SEABROOK STATION
Engineering Office:
1671 Worcester Road
Framingham, Massachusetts 01701
(617) - 872 - 8100

Subject: Submittal of Followup Documentation; Structural Engineering
Branch Design Audit

SEABROOK STATION, UNITS 1 & 2

NRC-SEB DESIGN AUDIT (3/29/82 to 4/2/82)

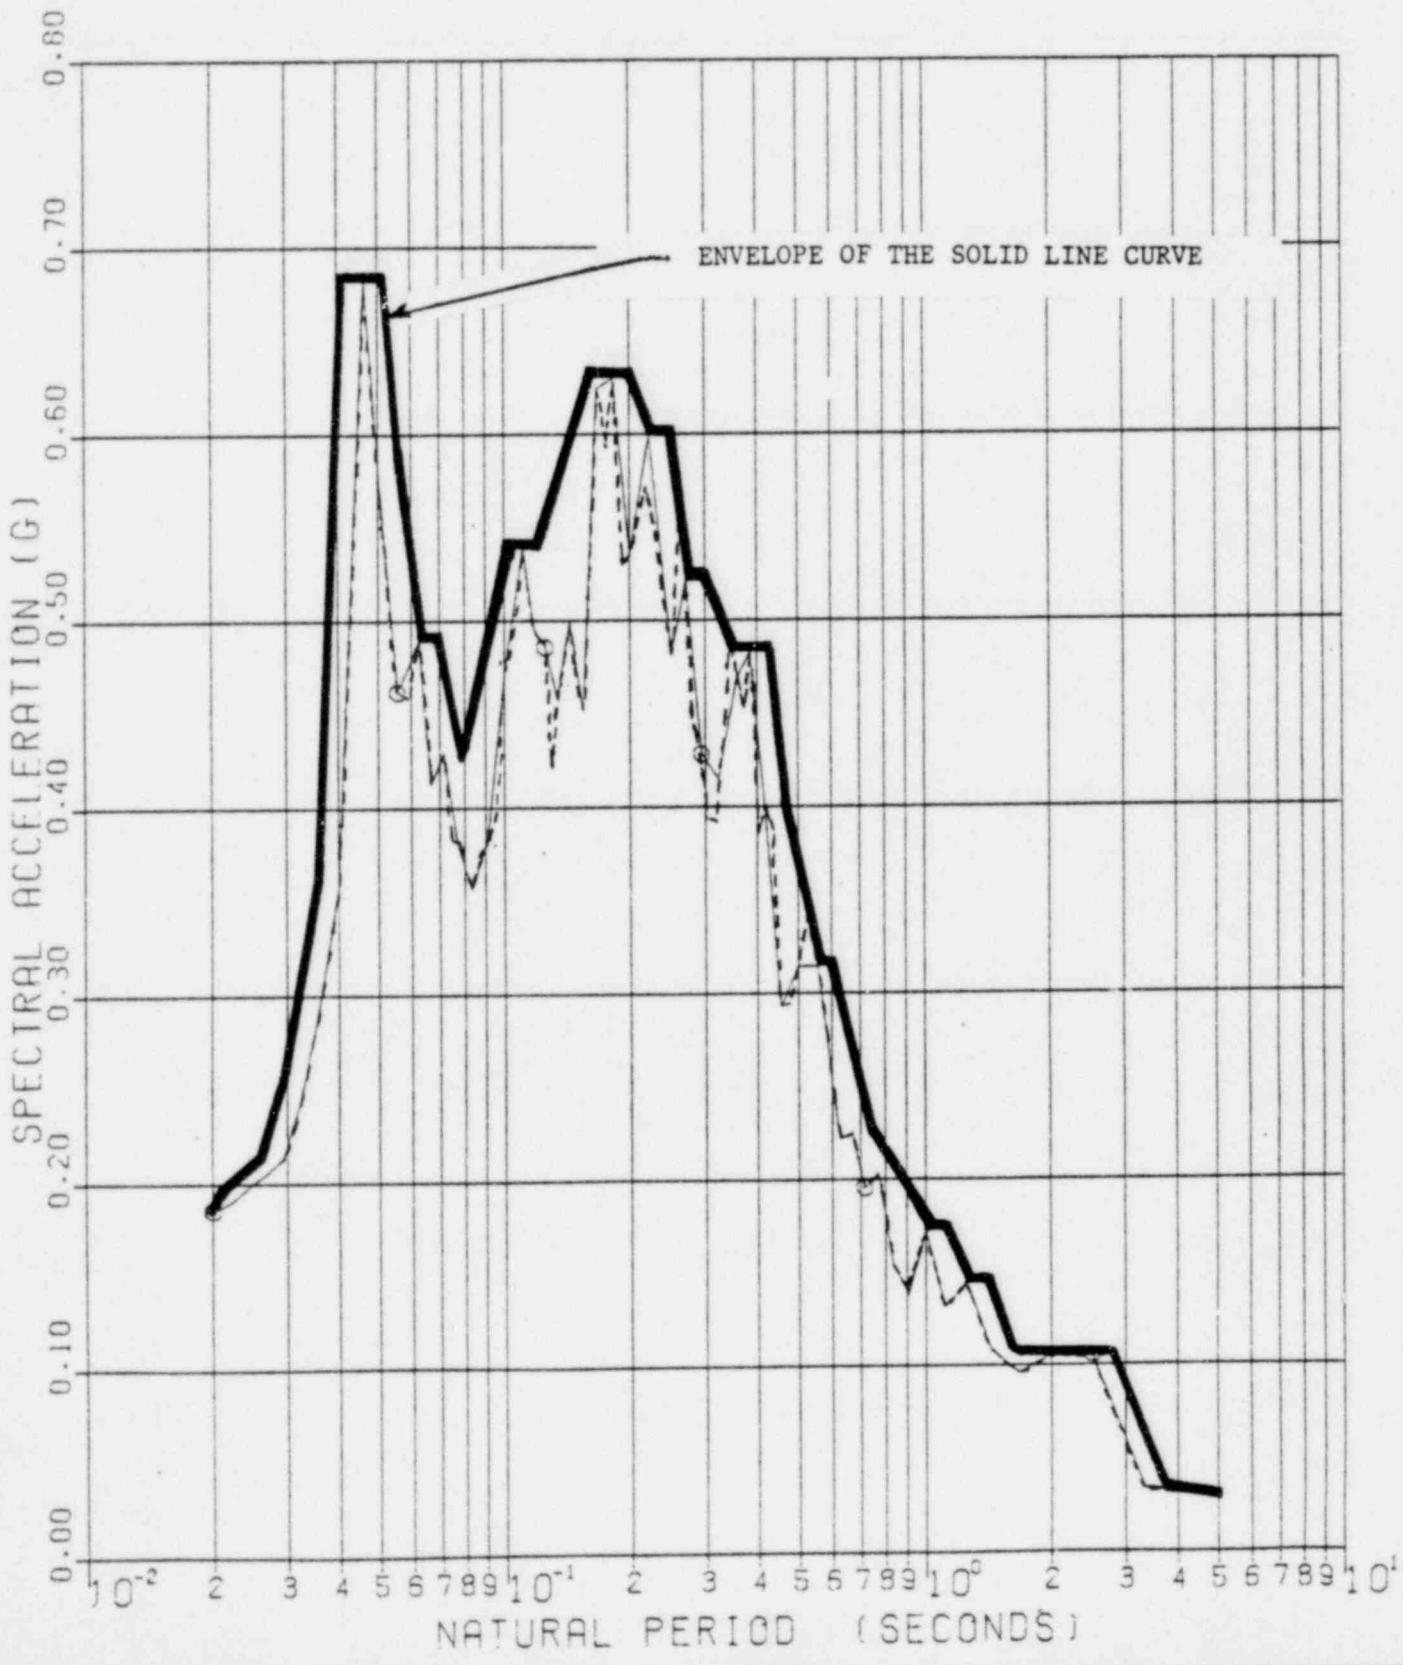
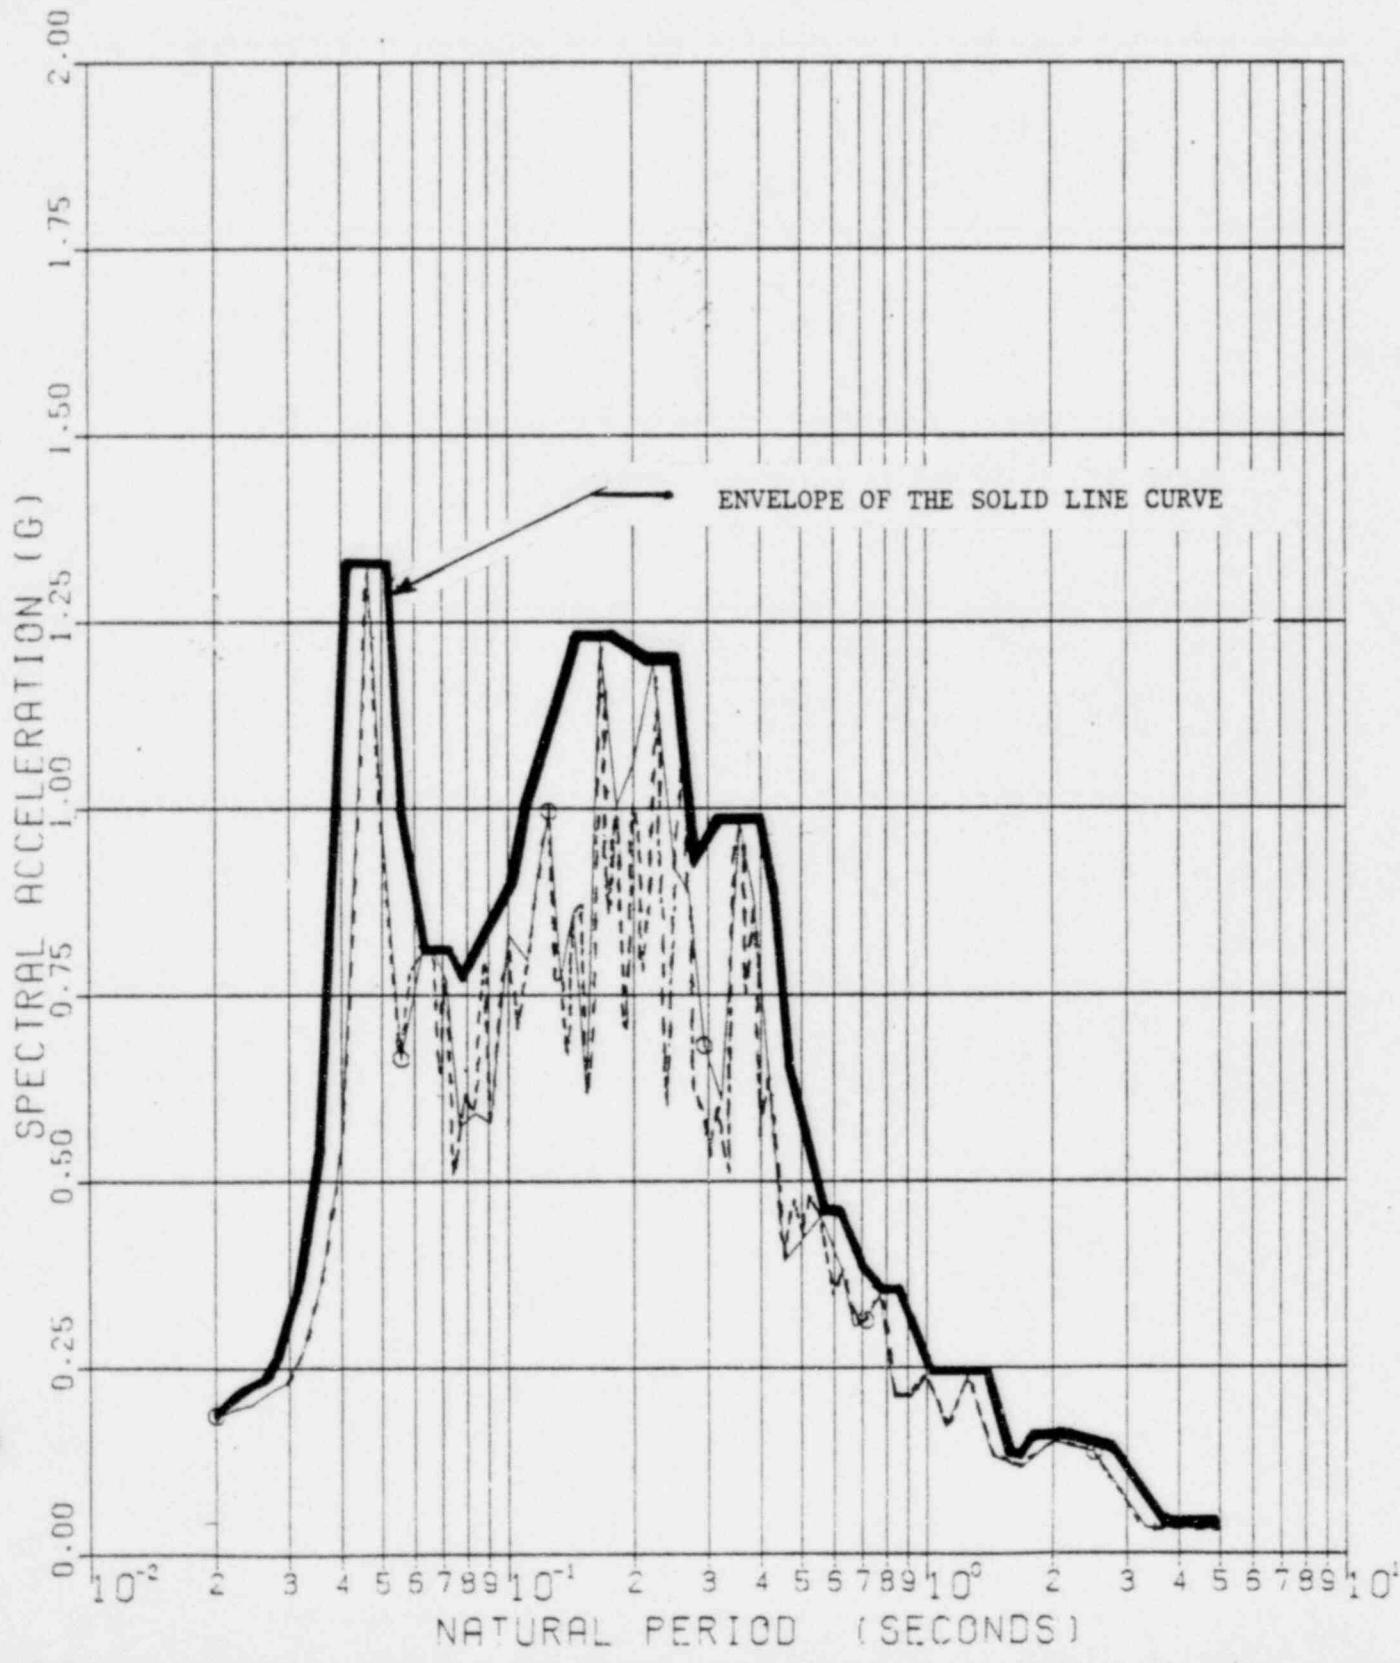
The frequency increments (Table 3.7(B)-21 of FSAR) used for calculating floor response spectra are larger than those suggested in SRP Section 3.7.1. Discuss the implications of these differences and justify your frequency intervals.

The frequency increments used for calculating floor response spectra are based on Table N-1226-1 of ASME Boiler and Pressure Vessel Code, Section III, Division 1, Nuclear Power Plant Components, 1980 Edition, Appendix N, 'Dynamic Analysis Methods'.

The natural frequencies of the structures were included in computing response spectra. The table shown in SRP Section 3.7.1 is for meeting the spectra-enveloping requirement of the design time history where the frequency intervals are required to be smaller.

The floor response spectra calculated at frequencies shown in above referenced Table N-1226-1 and at structural frequencies will produce accurate response spectra and will meet the intent of SRP Section 3.7.1 (and also R.G. 1.122).

A typical 1 and 4% response spectra plots, generated using frequency interval according to ASME Table N-1226-1, and the envelope of these spectra are presented in Figures 220-1 and 220-2 respectively. The floor response spectra, calculated using frequency interval according to Table in SRP Section 3.7.1 (or R.G. 1.122), are also shown in dotted lines on the same figures. The comparison of the spectra in these figures shows that the dotted line spectra have additional spectral amplitudes due primarily to different frequency interval. However, the results show that the dotted line spectra are consistently lower than the envelope of the spectra.
